IN THE DRAWINGS

REMARKS

Attorney Docket No. L9289.02148
STEVENS DAVIS, MILLER & MOSHER, L.L.P.
1615 L Street, N.W., Suite 850
P.O. Box 34387
Washington, D.C. 20043-4387
Telephone: (202) 785-0100
Facsimile: (202) 408-5200

FIG.1

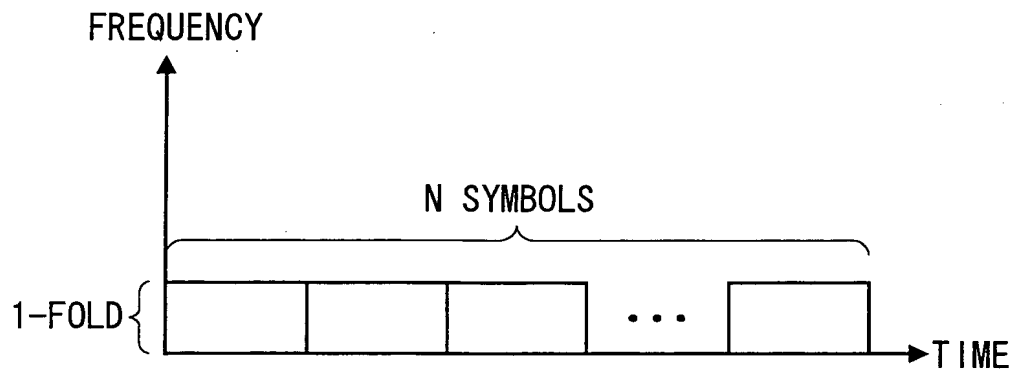
Replacement drawings for Figs. 1-7 are submitted herewith to overcome the objections thereto. Figs. 1-7 have been amended to include legends identifying them as related art.

RELATED ART
